Re: Minor Revision Request to Hillside Center for Sustainable Living

# HILLSIDE CENTER FOR SUSTAINABLE LIVING PHASE I SITE CONSTRUCTION PLANS

COTTAGE COURT & HILLSIDE AVENUE  
NEWBURYPORT, MASSACHUSETTS  
DATE: JULY 6, 2018

# Cottage Court Elevation Comparison due to Accessibility Design Changes

HILLSIDE CENTER FOR SUSTAINABLE LIVING  
IN  
NEWBURYPORT, MASSACHUSETTS  
COTTAGE COURT & HILLSIDE AVENUE  
PHASE I SITE CONSTRUCTION PLANS  
SITE LAYOUT PLAN  
DRAWING NO. C-1

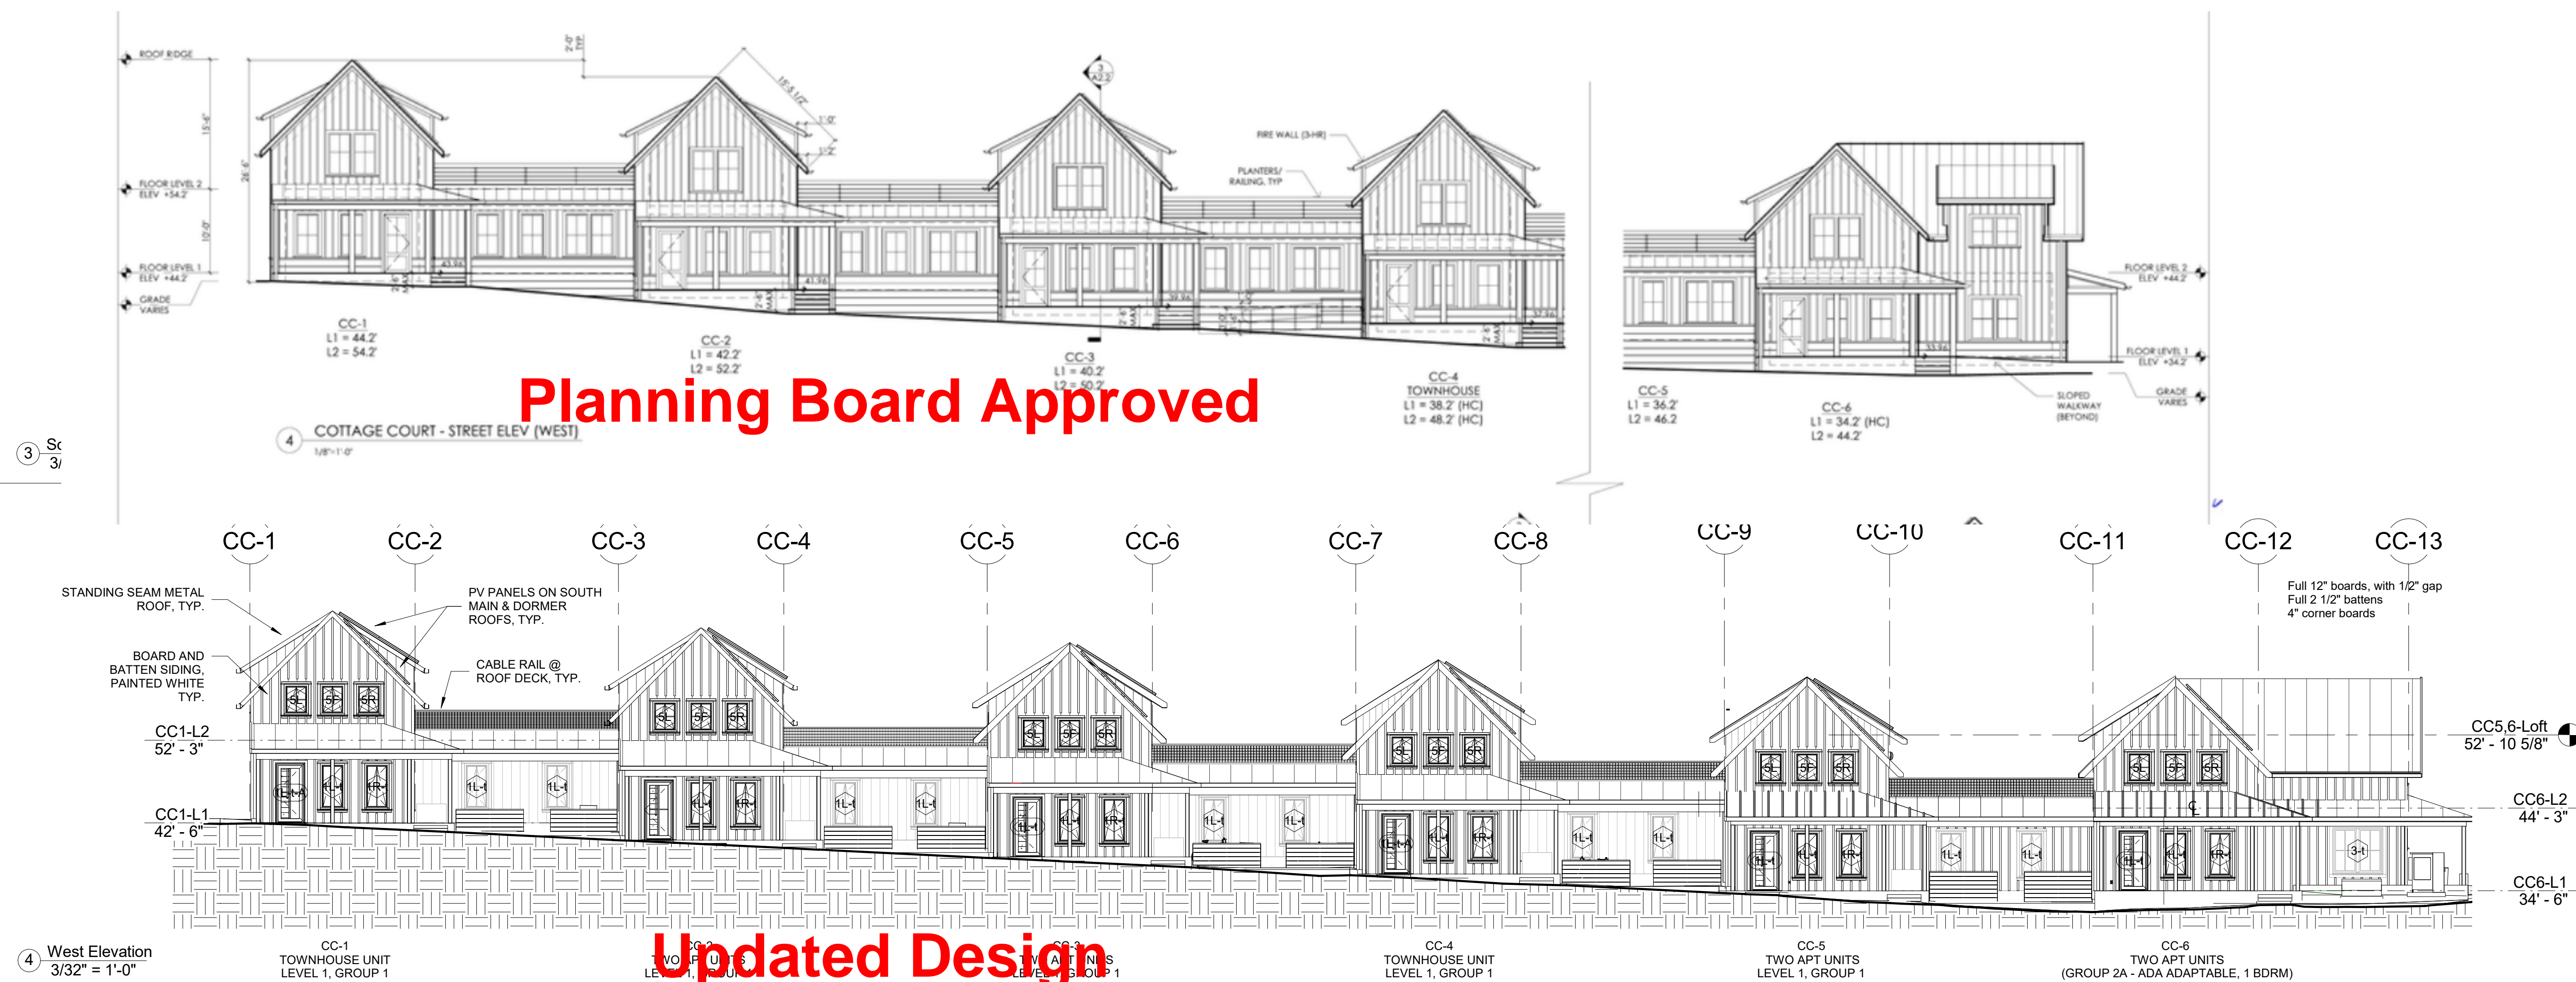
**CHANGED FROM FULLY TO PARTIALLY PAVED WITH CRUSHED STONE IN OTHER AREAS (See detail drawing)**

**REWORKED GRADES AND DROPPED ENTRY ELEVATION TO MEET ACCESSIBILITY VISITATION REQUIREMENTS (See Elevation drawings)**

**ELIMINATED 2 GREENHOUSES AND MADE THE REMAINING ONE A BIT LARGER**
